6.2 Containment Systems

The information in this section of the reference ABWR DCD, including all subsections, tables, and figures, is incorporated by reference with the following departures and supplements.

STD DEP 6.2-2 (Tables 6.2-1 and 6.2-2, Figures 6.2-2, 6.2-3, 6.2-4, 6.2-5, 6.2-6a and b, 6.2-7a and b, 6.2-8a, 6.2-8b, 6.2-8c, 6.2-9, 6.2-10, 6.2-11, 6.2-12a and 6.2-12b, 6.2-13a and 6.2-13b, 6.2-14, 6.2-15, 6.2-22, 6.2-23a, 6.2-23b, 6.2-24, 6.2-25a, and 6.2-25b.)

Figure 6.2-4 Feedwater Line Break Flow Enthalpy—Feedwater System Side of Break

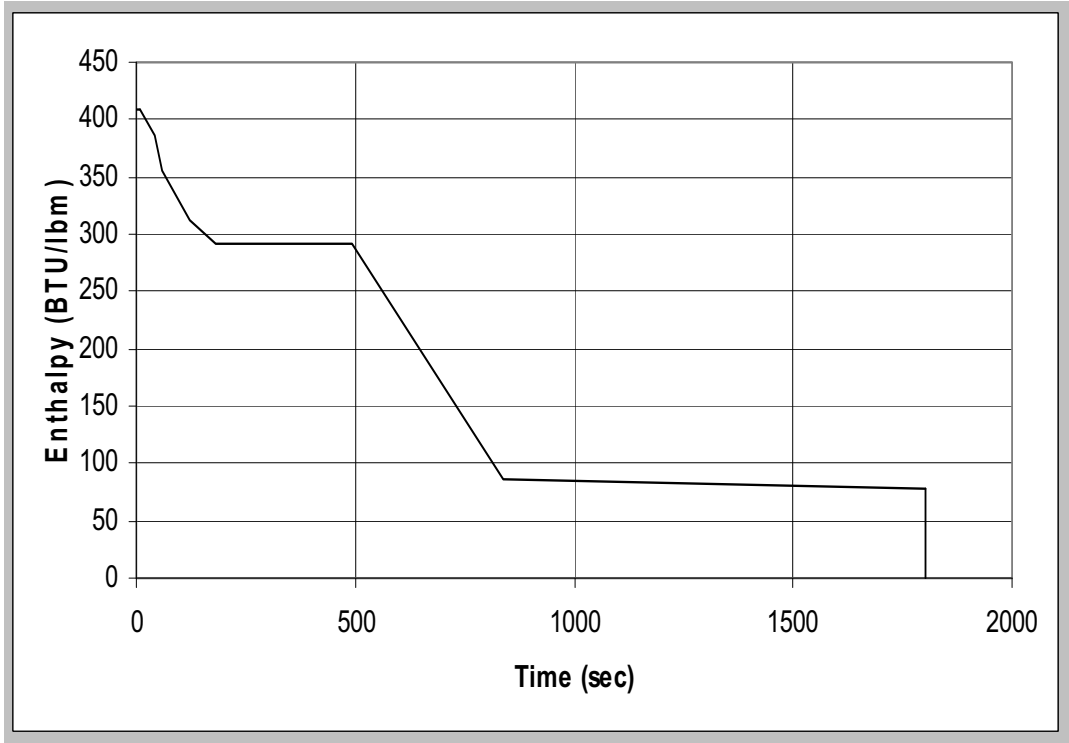
In order to provide further assurance of conservatism, FWLB mitigation is added to the ABWR design. The system is described in Section 7.3.1.1.2. The specific enthalpy time history, assuming the break flow of Figure 6.2-3, is shown in Figure 6.2-4. Initial reactor power is assumed to be 102% NBR.

Figure 6.2-6a Drywell Pressure Response for Feedwater Line Break

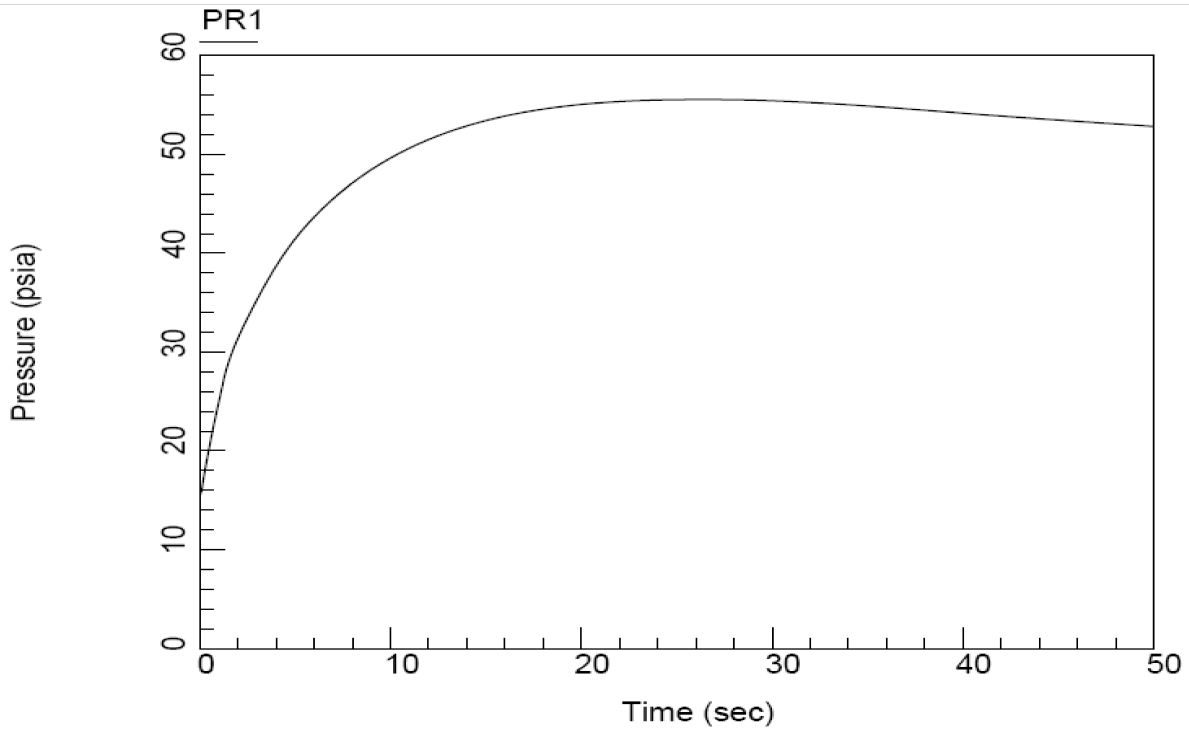
~~The calculated containment pressure and temperature responses for a feedwater line break are shown in Figures 6.2-6 and 6.2-7, respectively. The peak pressure (268.7 kPaG) and temperature (140°C) occur in the drywell. The containment design pressure of 309.9 kPaG is 115% of the peak pressure.~~

The short term pressure peak (268.7 kPaG) of Figure 6.2-6 is the peak pressure for the whole transient. Figure 6.2-8 shows temperature time histories for the suppression pool, wetwell, and drywell temperatures. The peak pool temperature (99.6°C) is reached at 6600 seconds (1.833 hours). This is less than the suppression pool temperature value of 100°C which is used in the net positive suction head available (NPSHA) calculations.

Figure 6.2-9 ABWR Main Steamlines with a Break

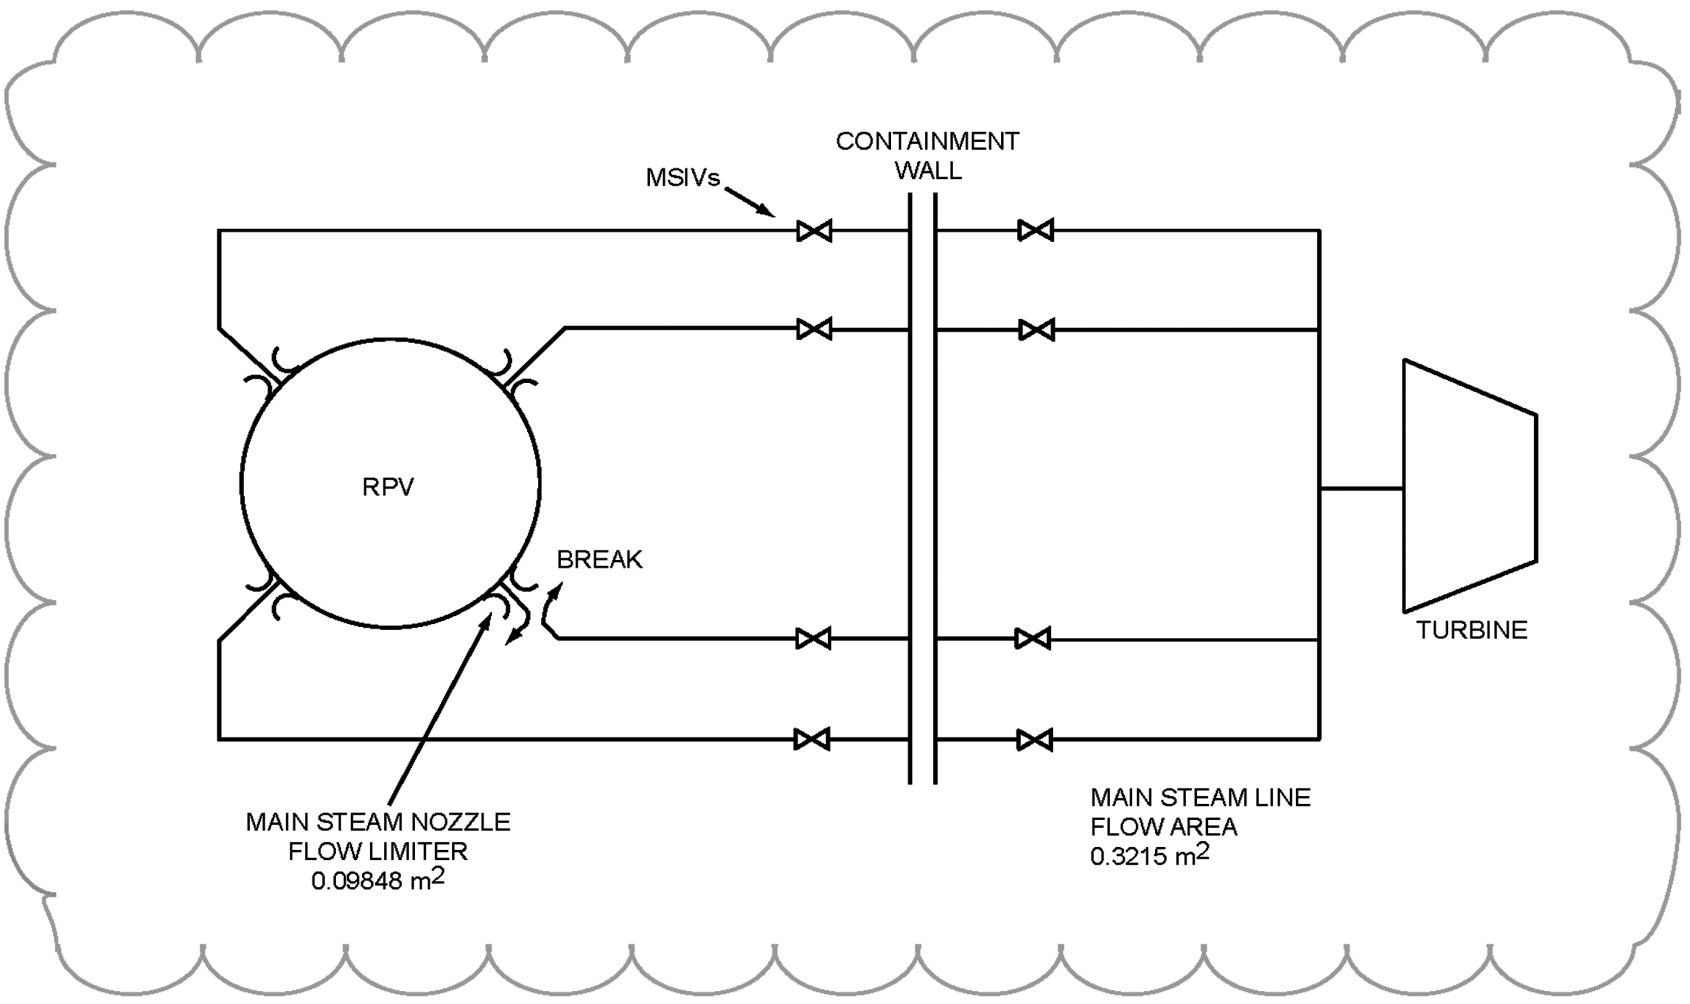
A schematic of the ABWR main steamlines, with a postulated break in one of the main steamlines, is shown in Figure 6.2-9. The main steamline (MSL) break is a double-ended break with one end fed by the RPV directly through the broken line, and the other fed by the RPV through the unbroken main steamlines until the MSIVs are closed. Once the MSIVs are closed, the break flow is only from the RPV through the broken line.

Each MSL contains a flow limiter built into the MSL nozzle on the RPV with a throat area of 0.09848 m², as shown in Figure 6.2-9. This flow limiter provides the effective break area for the vessel side.

- (1) Each MSL contains a flow limiter built into the MSL nozzle on the RPV with a throat area of 0.0983m², as shown in Figure 6.2-9.*
- (2) The break is located in one MSL at the inboard MSIV.*
- (3) During the inventory depletion period, the flow multiplier of 0.75 is applied (Reference 6.2-1).*
- (4) The flow resistance of open MSIVs is considered. A conservative value of 2.062 for pressure loss coefficient for two open MSIVs was taken. The nominal value is approximately 3.0. When the open MSIV resistance is considered, the flow chokes at the MSIV on the piping side as soon as the inventory depletion period ends. The effective flow area on the piping side reduces to 70% of a frictionless piping area. The value of 70% applies to flow of steam and twophase mixture with greater than 15% quality.*

Figure 6.2-12a Drywell Pressure Time History for MSLB

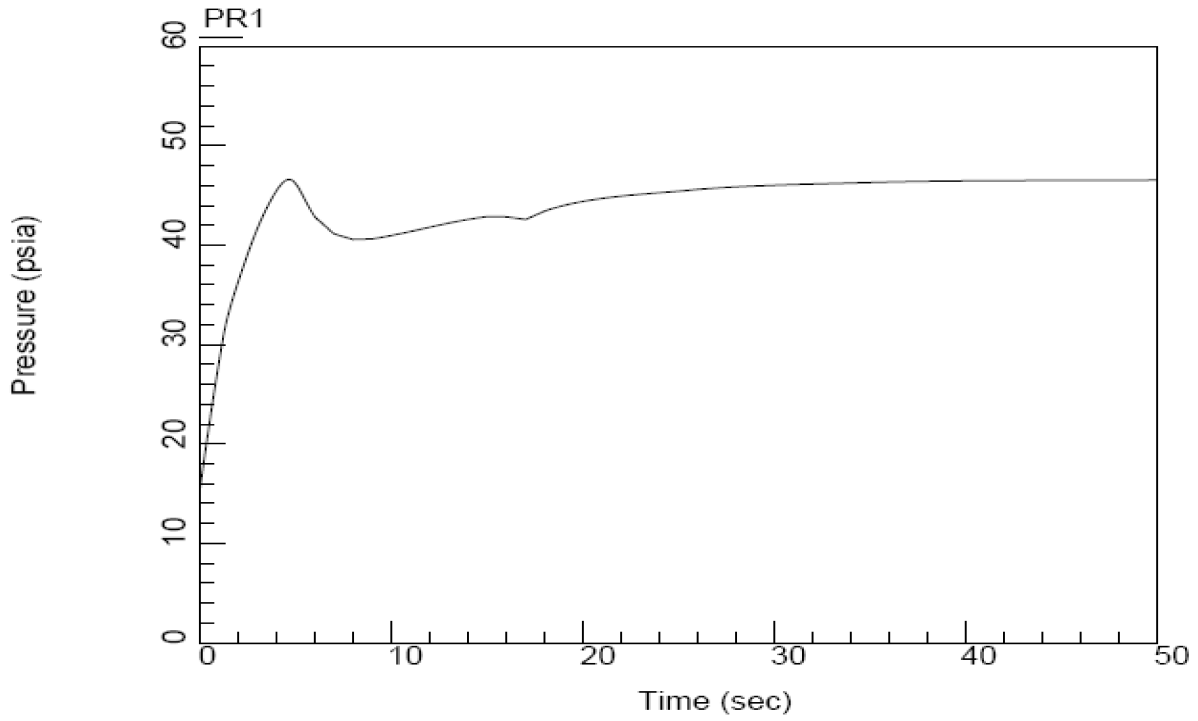
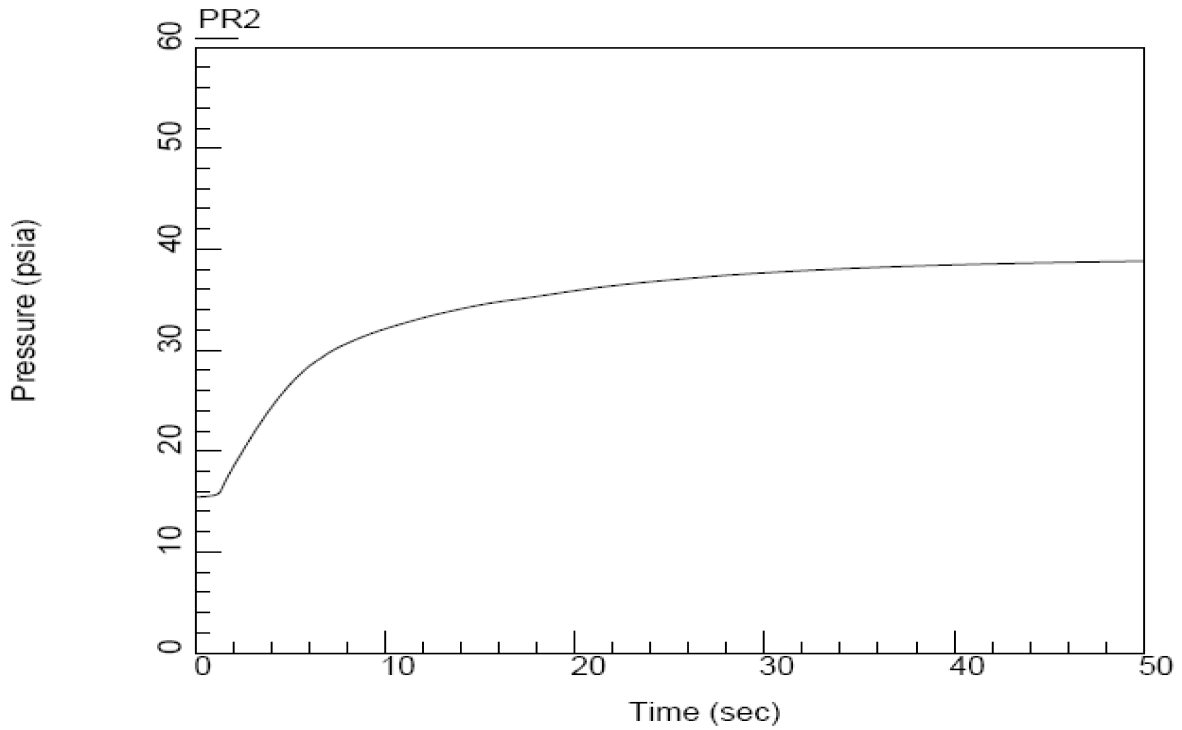
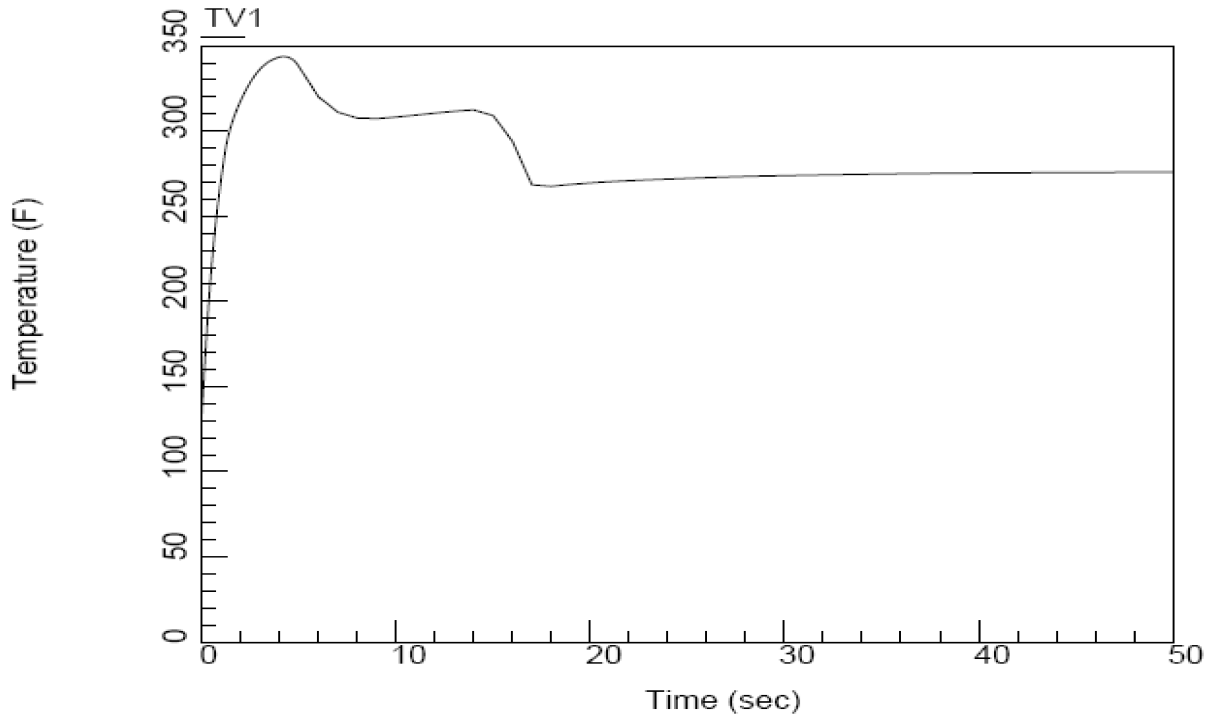
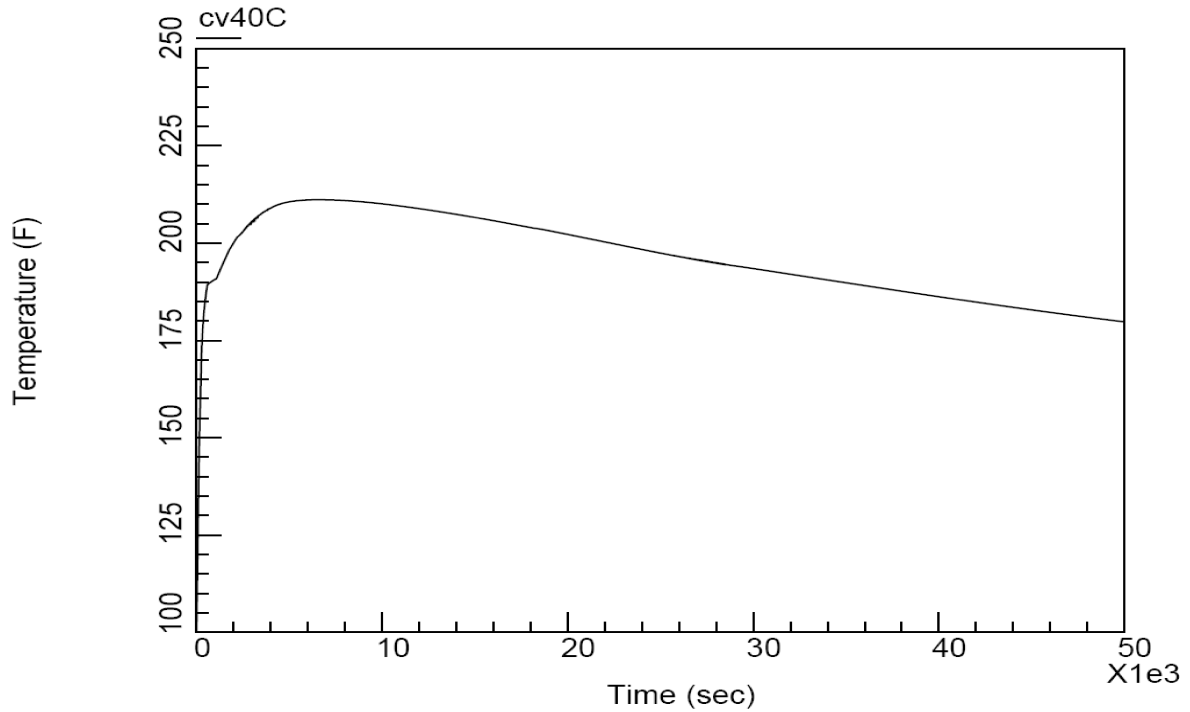
Figures 6.2-12 through 6.2-15 and 6.2-13 show the pressure and temperature responses of the drywell and wetwell during the blowdown phase of the steamline break accident.

The maximum drywell temperature (173.2°C) is predicted to occur for the steamline break. The MSLB with two-phase blowdown starting when the RPV collapsed water level is at or below the main steamline nozzle provides the highest peak drywell temperature. The peak drywell air temperature is 169.7/173.2°C, below the which is above the design value of 171.1°C, and is the limiting one as compared to the FWLB peak temperature. As noted in Section 6.2.1.1.2.1, this peak calculated drywell temperature exceeds the design limit for only 2 seconds. The peak drywell pressure for the MSLB remains below that for the FWLB, which becomes the most limiting. The peak drywell temperature and pressure is below the design temperature and pressure. The MSLB is the limiting event for peak drywell temperature. The FWLB is the most limiting for drywell pressure.

The long-term containment pressure and temperature responses following the MSLB accident remain below those for the feedwater line break, which is the most limiting event. The long-term containment pressure response following the MSLB accident remains below that for the feedwater line break. The long-term temperature response remains below that for the peak achieved in the short term for the steam line break shown in Figure 6.2-13.
